CONTINUING ELIGIBILITY INSPECTION (CEI) REPORT
FOR HURRICANE & SHORE PROTECTION PROJECTS
Honolulu Engineer District
CEPOH-EC-T

1. Project Name: Vatia Shore Protection Project
2. Date of Inspection: April 13, 2004
3. Inspection Personnel:

Overview of Vatia SPP

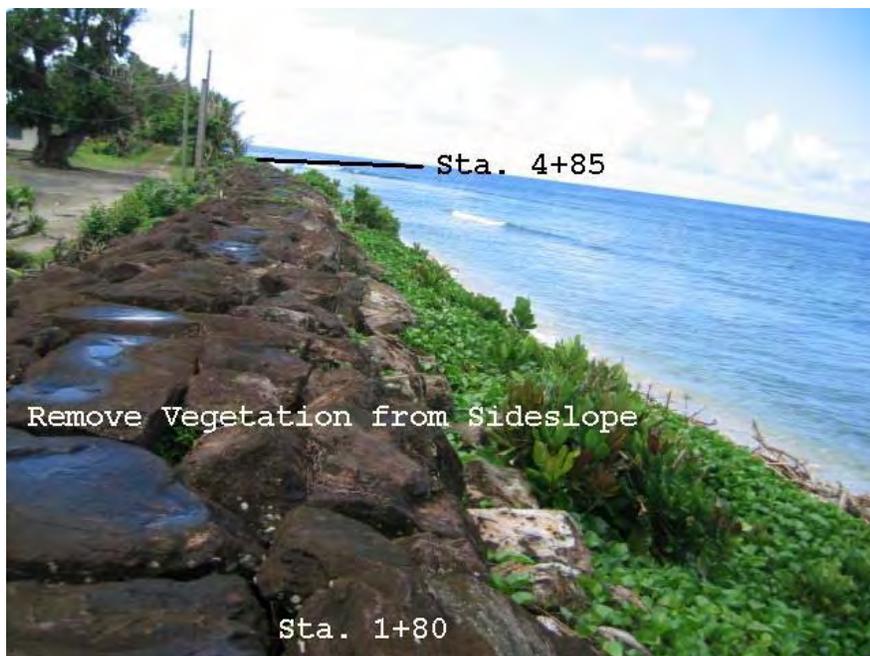
- a. Sta. 0+50 Interior tieback, remove vegetation growing among interior toe stones.

- b. Sta. 0+50 - 1+35, Remove vegetation that covers structure.
- c. Sta. 2+10 a 15', The coral road through the revetment is OK.

d. Sta. 1+55, Structure not visible from +10' to toe of revetment.

e. Sta. 1+80 - Sta. 4+85, Structure not visible from +10' to toe of revetment at numerous locations.

f. Sta. 2+50, interior-side, remove debris and vegetation.

g. Sta. 4+75, Unable to inspect crest due to vegetation.

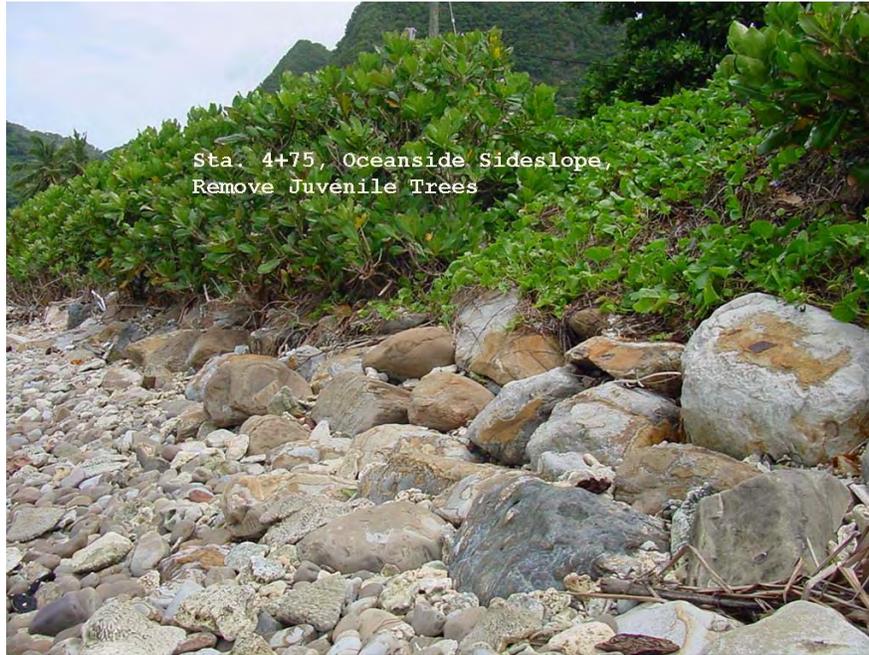
- h. Sta. 5+00, Visible for approx. 20'.
(The entire structure should be like this)

- i. Sta. 5+00 - Sta. 6+30, Remove vegetation.
